Consolidated version of Supplement 8 to the 03 series of amendments to UN Regulation No. 51

The text reproduced below has been prepared by the experts of the Informal Working Group on Measurement Uncertainties (IWG MU), the experts of the Informal Working Group on Additional Sound Emission Provisions (ASEP) and by the experts from the International Organization for Standardization (ISO). In this text, documents GRBP/2022/13, GRBP/2022/16 and GRBP-76-09 all presented and adopted at the 76th session of GRBP have been consolidated. The documents have been prepared to utilize the latest ISO 10844 standard test surface and also to improve measures to reduce variability in the Regulation.

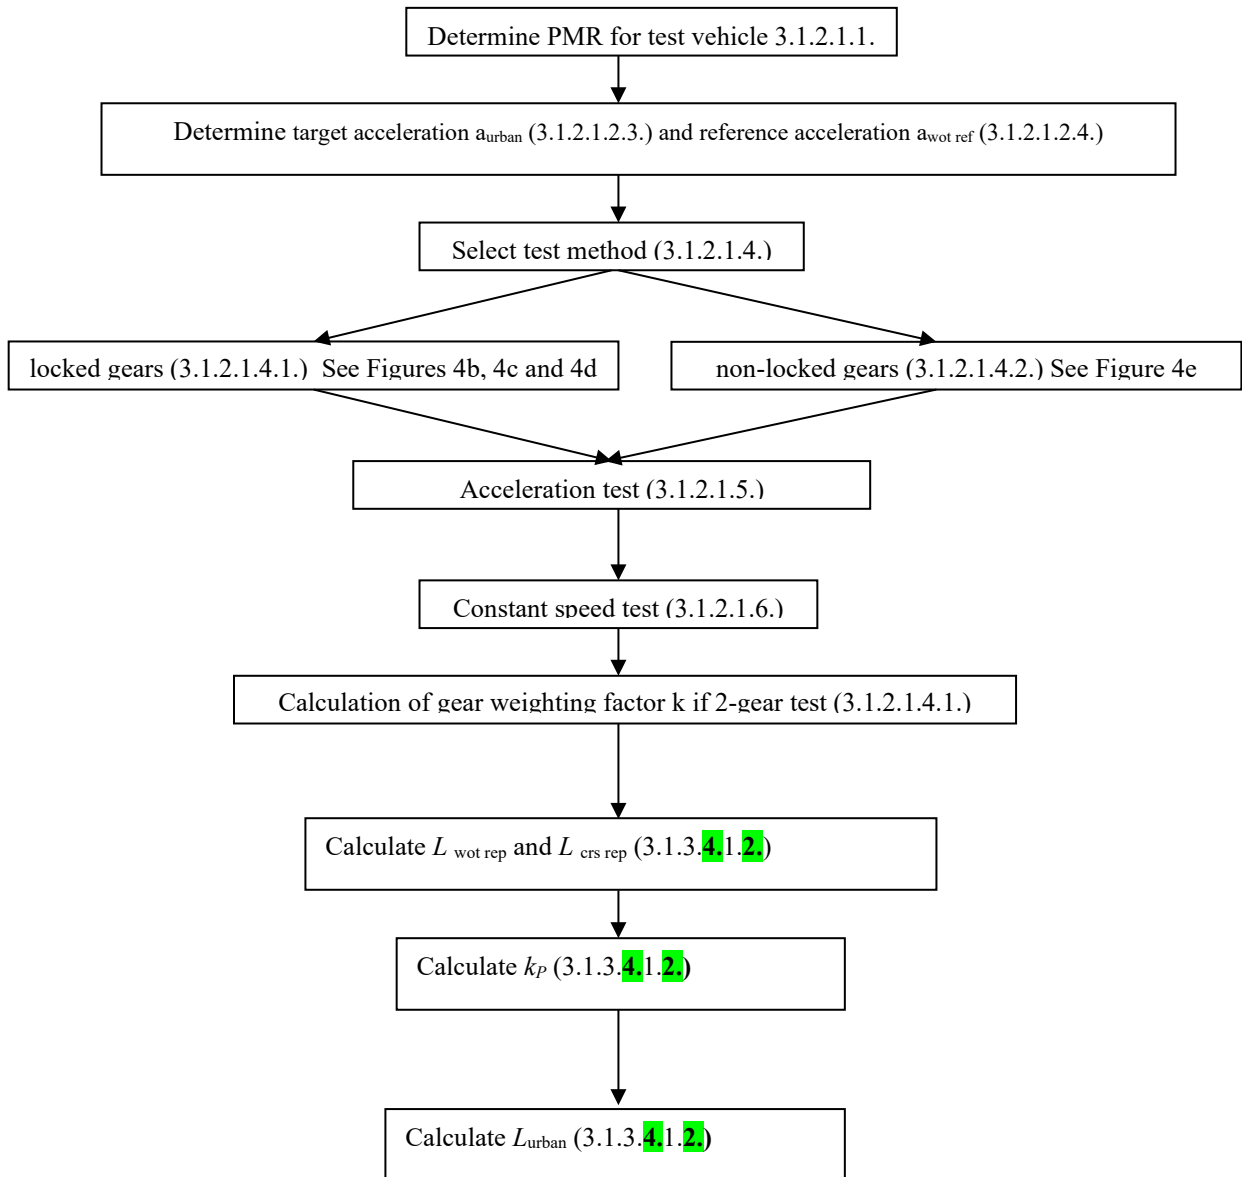
In cases where $L_{wot,rep}$ is less than $L_{crs,rep}$:

In cases where $L_{wot,rep}$ is less than $L_{crs,rep}$ the final result L_{urban} is the result of the cruise test:

6. To avoid confusion due to a reported value of L_{urban} , which may be smaller than L_{crs} in this special case, L_{urban} is set to L_{crs} , as shown in the diagram below.

$$k_p=1$$

$$L_{urban} = L_{crs,rep}$$

"Figure 4b

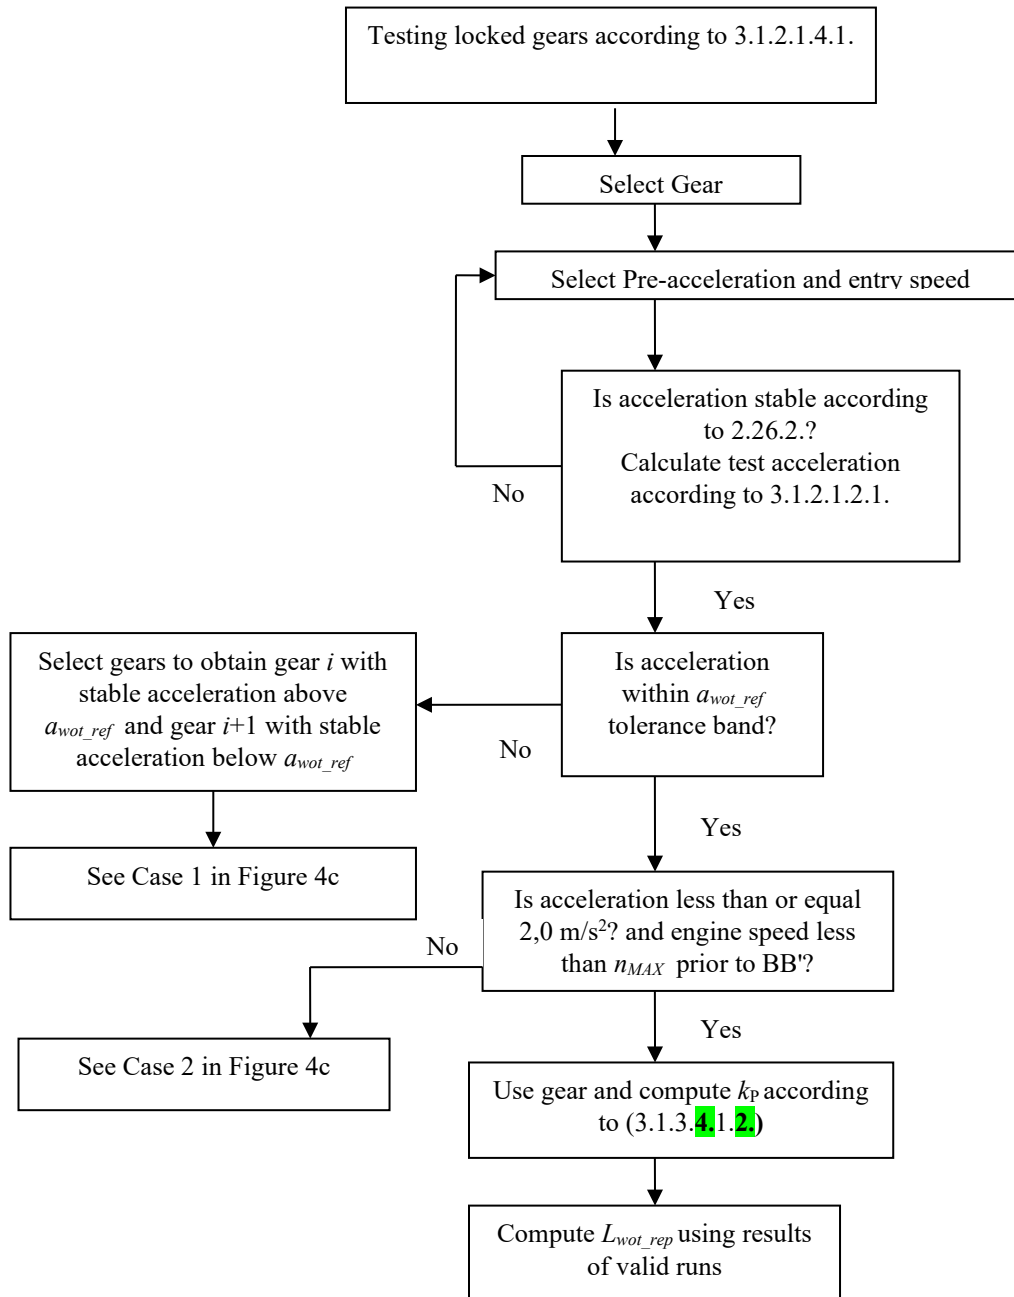
Annex 3, Appendix 1, Figure 4b, amend to read:

7. The content of paragraph 3.1.3.1. was moved to paragraph 3.1.3.4.1.2. without any change when RD-ASEP was introduced in Supplement 7. In the figures, references to this paragraph 3.1.3.1. need to be renumbered to 3.1.3.4.1.2., accordingly.

"Figure 4c
**Flowchart for vehicles tested according to paragraph 3.1.2.1. of Annex 3 to this Regulation –
 Gear selection using locked gear PART 2**

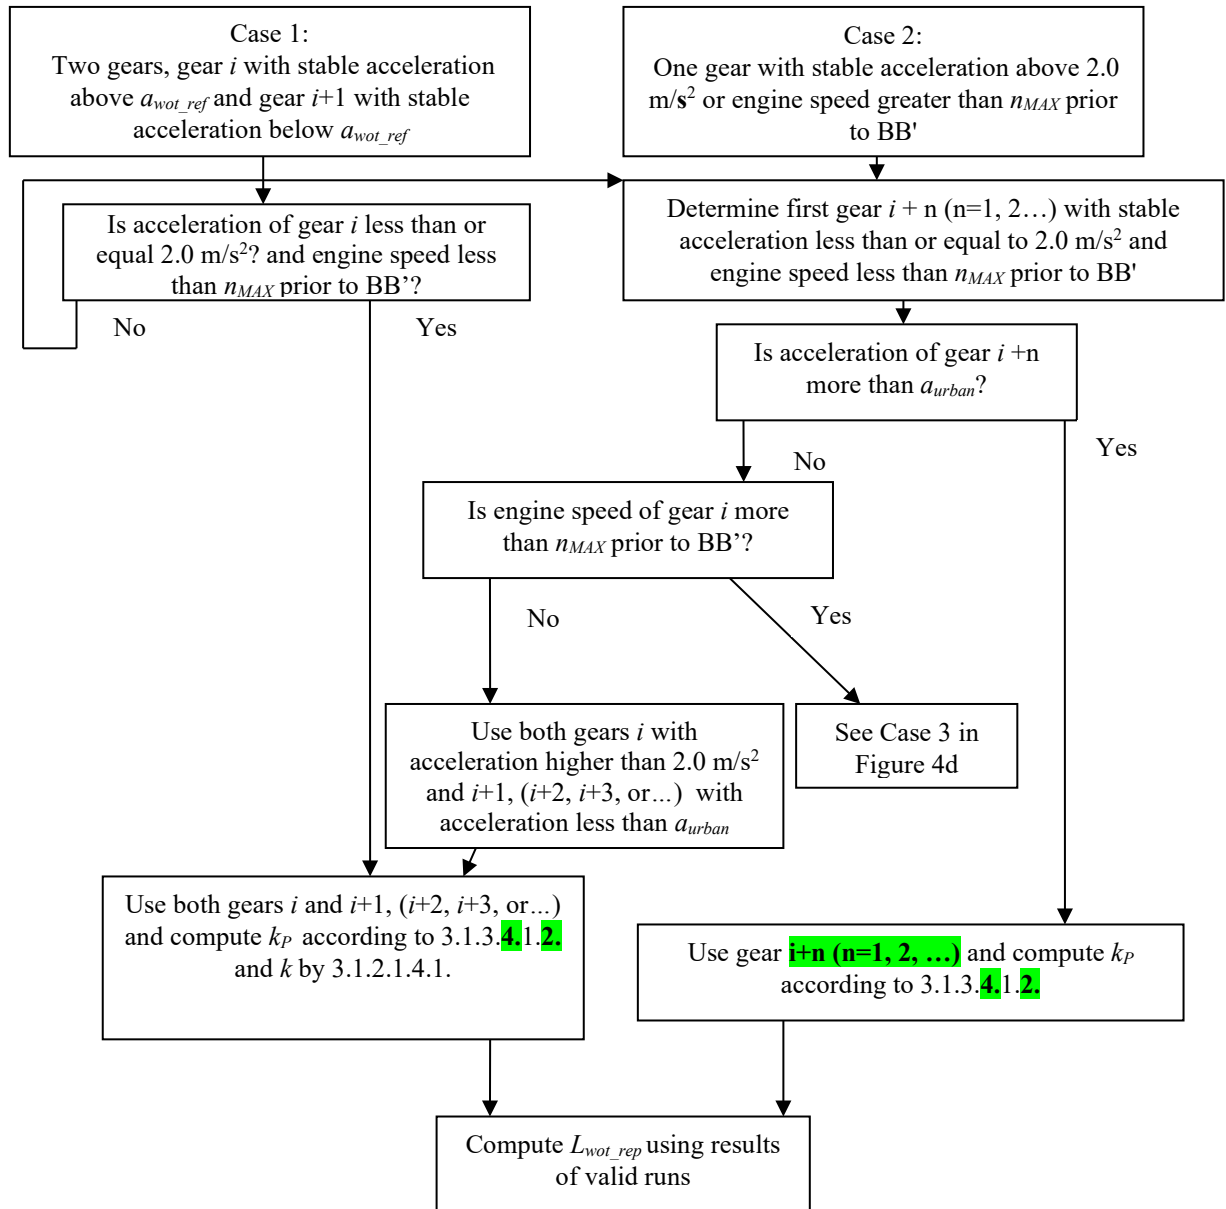
Annex 3 – Appendix 1, Figure 4c, amend to read:

8. In Figure 4c, from the current wording in Annex 3, paragraph 3.1.2.1.4.1.(c), the addition of "i+n (n=1, 2, ...)" in the box "Use gear and compute k_p according to 3.1.3.4.1.2." was made for better understanding and clarification.

"Figure 4d

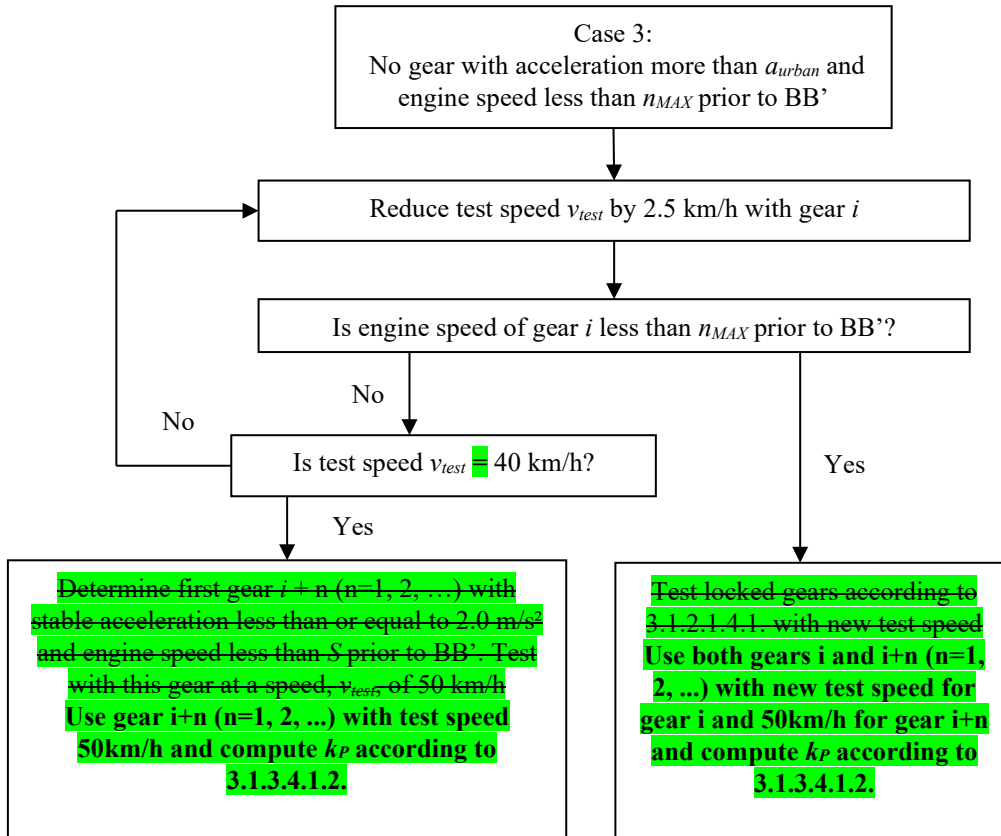
Annex 3 – Appendix 1, Figure 4d, amend to read:

9. In Figure 4d, to avoid misinterpretation, the following modifications were made from the current wording in Annex 3, paragraph 3.1.2.1.4.1.(d) for clarification and better understanding:

- Adding "=" in the box "Is test speed v_{test} 40km/h".
- Replacing "Determine first gear $i + n$ (n=1, 2, ...) with stable acceleration less than or equal to 2.0 m/s² and engine speed less than S prior to BB". Test with this gear at

a speed, v_{test} , of 50 km/h” by “Use gear $i+n$ ($n=1, 2, \dots$) with test speed 50km/h and compute k_p according to 3.1.3.4.1.2”.

- Replacing “Test locked gears according to 3.1.2.1.4.1. with new test speed” by “Use both gears i and $i+n$ ($n=1, 2, \dots$) with new test speed for gear i and 50km/h for gear $i+n$ and compute k_p according to 3.1.3.4.1.2.”

"Figure 4e

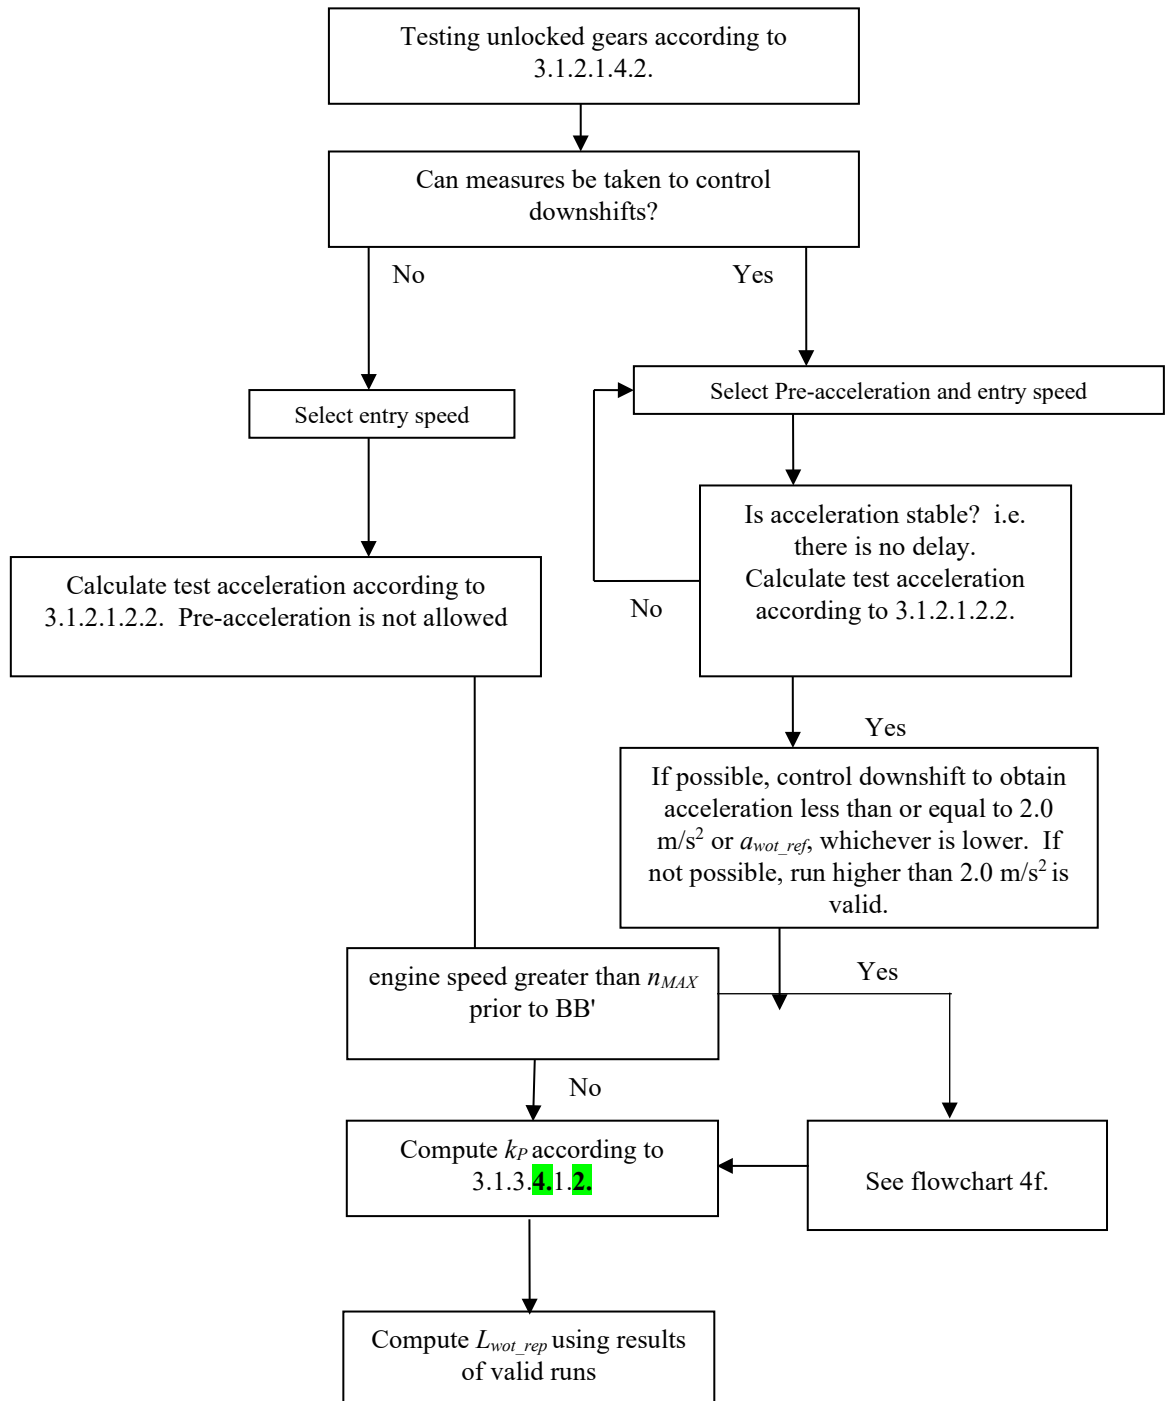
Annex 3 – Appendix 1, Figure 4e, amend to read:

“Figure 4f

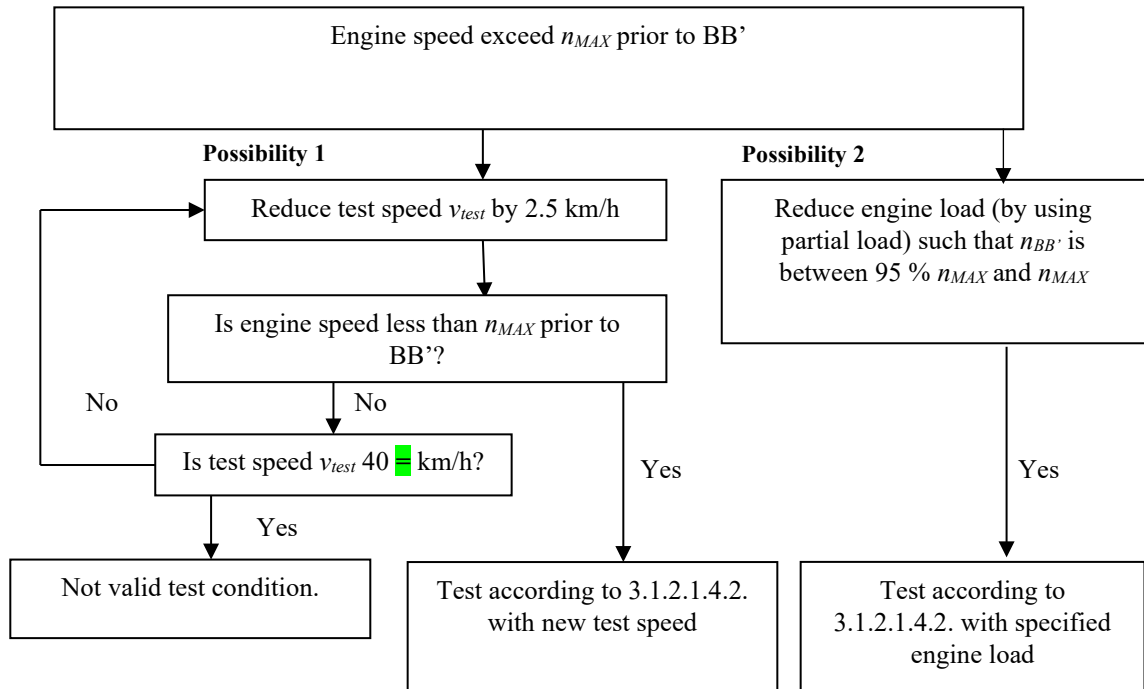
Annex 3 – Appendix 1, Figure 4f, amend to read:

10. In Figure 4f, from the current wording in Annex 3, paragraph 3.1.2.1.4.2., the addition of “=” in the box “Is test speed v_{test} 40km/h” was made for better understanding and clarification.
